**MUNICIPAL PLANNING COMMISSION
WORK SESSION AGENDA
September 9 , 2026, 12:00 pm**

Planning Commission Work Session 9-9-2026

Request: Design Review for 3415 and 3423 Dayton Boulevard

REVISED PLAT- LOTS 1-4

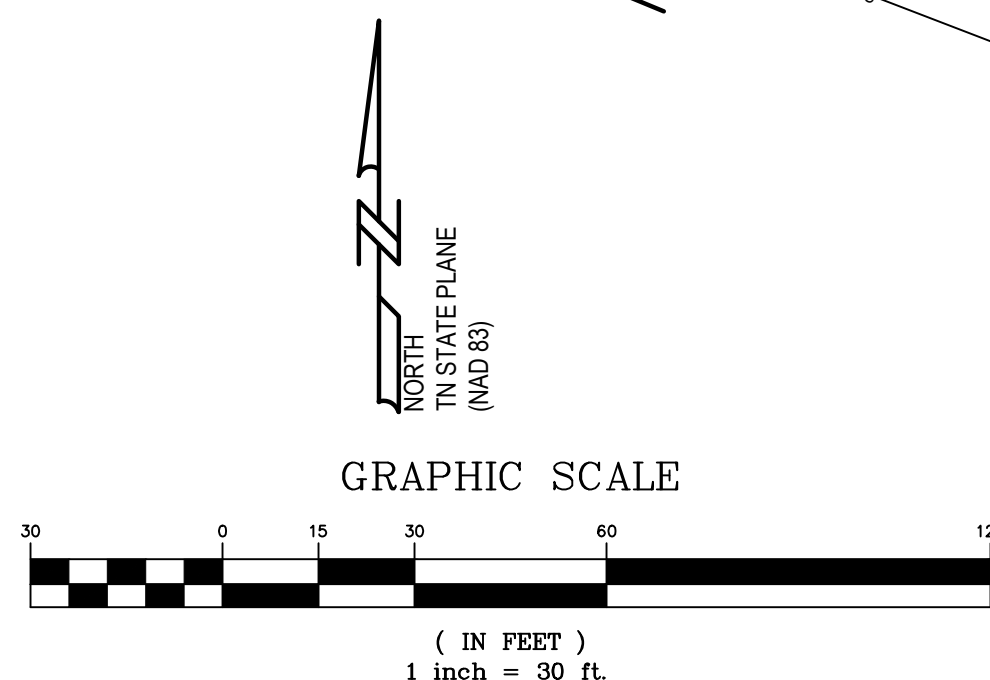
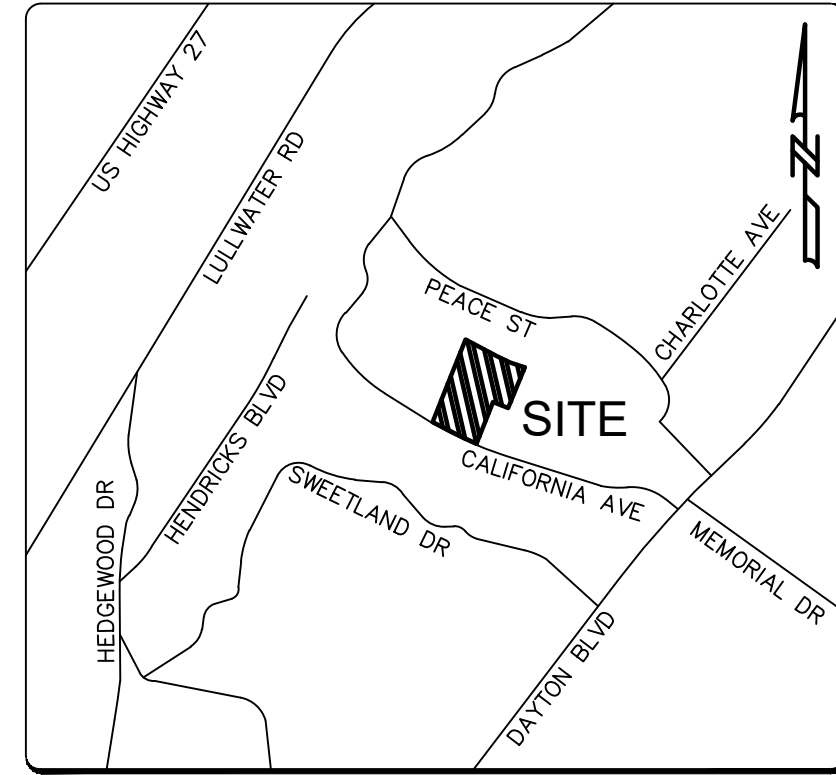
The purpose of the ordinance is to promote more predictable and prudent development decisions in line with emerging developmental goals for the city. The plat matches the site plan submitted for the rezoning in June 2026. The proposed subdivision and resulting flag lot meet the requirements of the flag lot ordinance and the development standards.

On August 26, 2026 a motion to approve the plat failed with only two (2) votes in favor. TN Code § 13-3-404 states that “(...) *The ground of disapproval of any plat shall be stated upon the records of the commission*”. Staff asked for the basis for not approving the plat but no reason was given, ostensibly due to the possibility of pending legal action.

FINAL PLAT

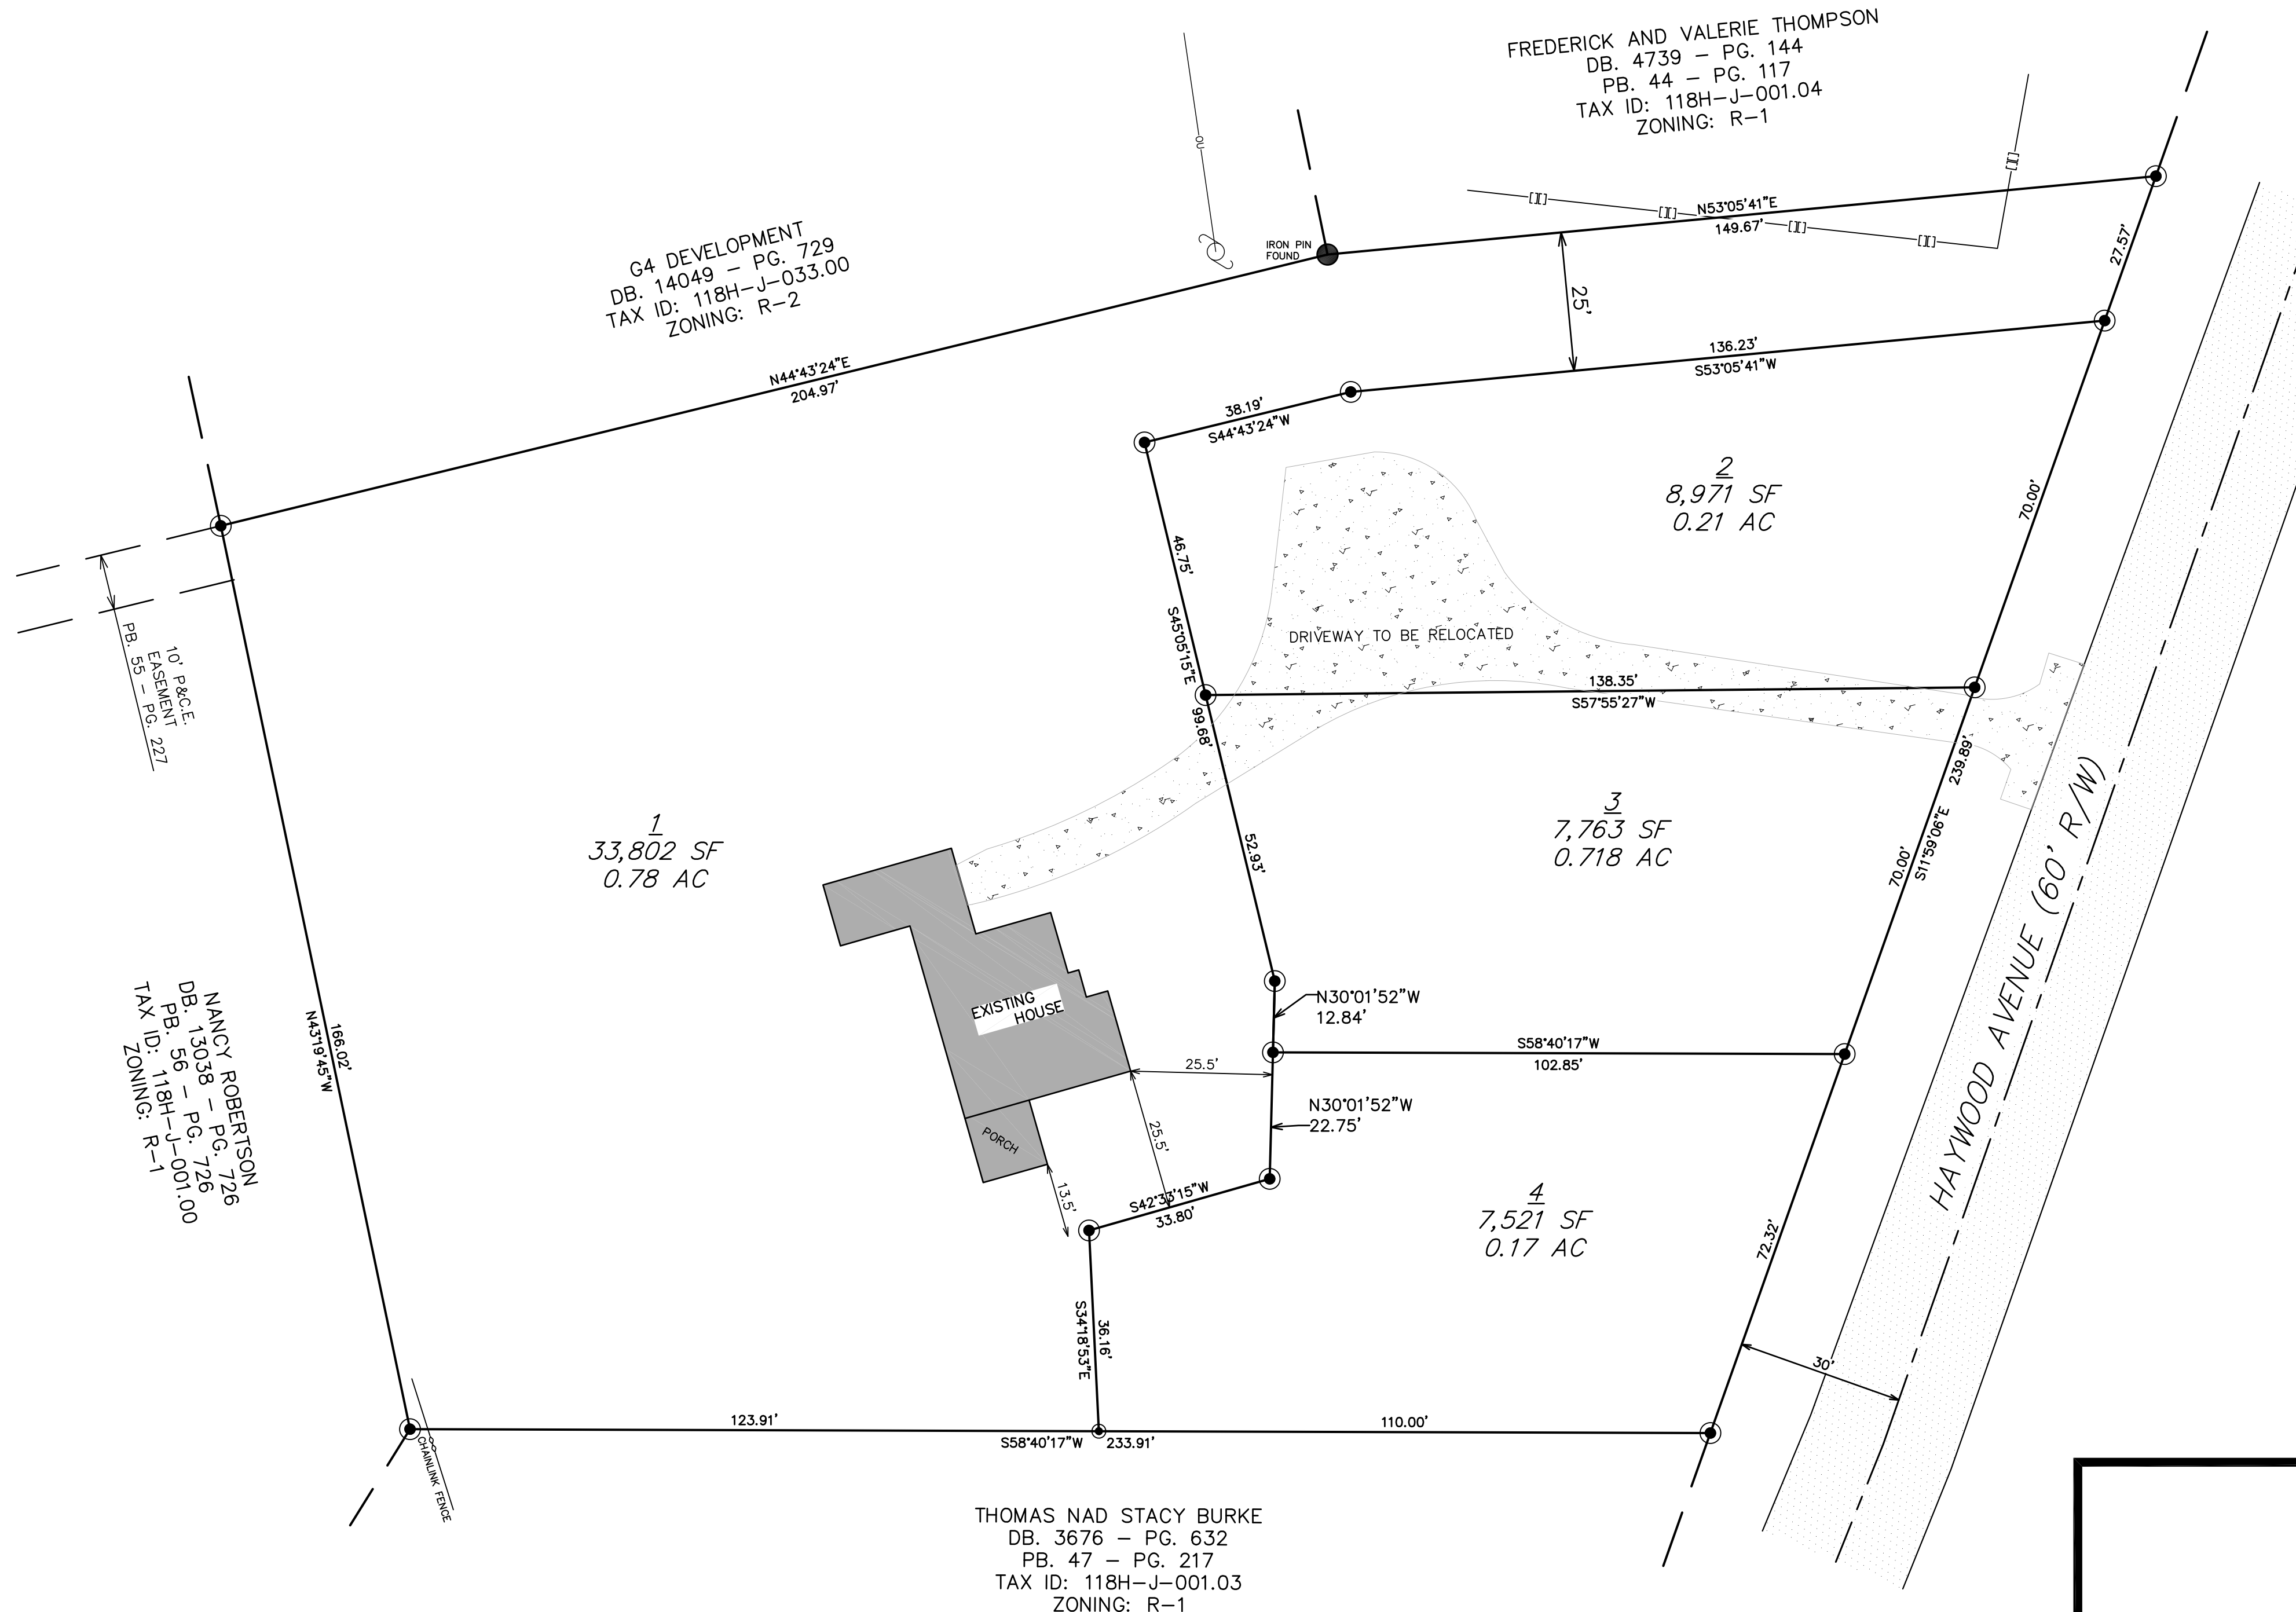
The purpose of the ordinance is to promote more predictable and prudent development decisions in line with emerging developmental goals for the city. The proposed subdivision and resulting flag lot meet the requirements of the flag lot ordinance and the development standards.

On August 26, 2026 a motion to deny the plat passed. TN Code § 13-3-404 states that “(...)The ground of disapproval of any plat shall be stated upon the records of the commission”. The applicant representative asked for the basis for not approving the plat but no reason was given. The planning commission stated that it was important for the property owner to be present to address community concerns. It should be noted that the planning commission by-laws allow for applicant representatives to speak during meetings.

SITE PLAN

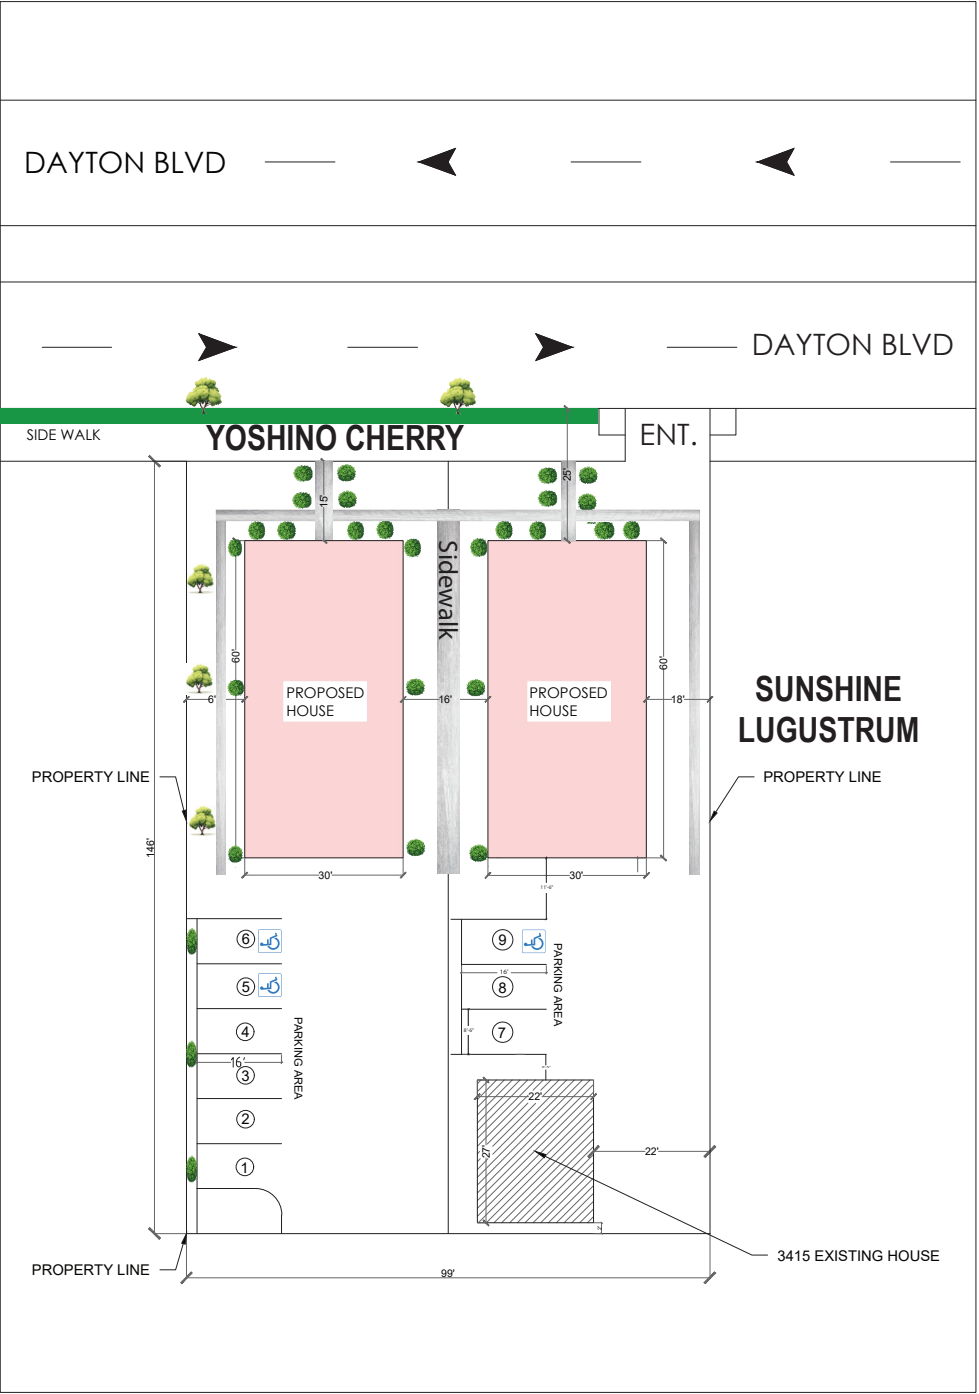
- New buildings must be setback zero (0) feet from the back of the sidewalk, unless a Storefront area with a maximum width of eight (8) feet is provided between the Sidewalk and the Building Zone.

- o ***Building is setback 15' from the sidewalk and does not provide an 8' storefront area. The applicant has requested a variance for this requirement.***

- Parking lot lighting shall be appropriate to create adequate visibility at night and evenly distributed to increase security. Parking lots must have a minimum illumination of 0.8 foot-candles at the ground level.

- o ***Ground level illumination not shown, but product cut sheet implies that minimum illumination is met. At the August regular session, the commission requested a photometric site plan to confirm the requirement is met.***

- Design standards and requirements that relate to trees, vegetation, terrain and waterways were not met.
 - o On sites with existing mature trees, at least a third (33%) of specimen trees shall be preserved or transplanted on site, to the maximum extent practicable. For purposes of this section, "specimen" trees include the following:

- ***Based on the google street view from 2023, the site had 4 trees along the 3417 Dayton Blvd. property line, 1 tree on the middle property line approximately 10' from the back of the sidewalk, and 1 tree approximately 90' from the back of the sidewalk and approximately 20' from the 3417 Dayton Blvd. property line. The tree species are unknown and the DBH of the trees is unknown. At the August regular session, the commission requested a site specific landscaping plan to address the removal of mature trees.***
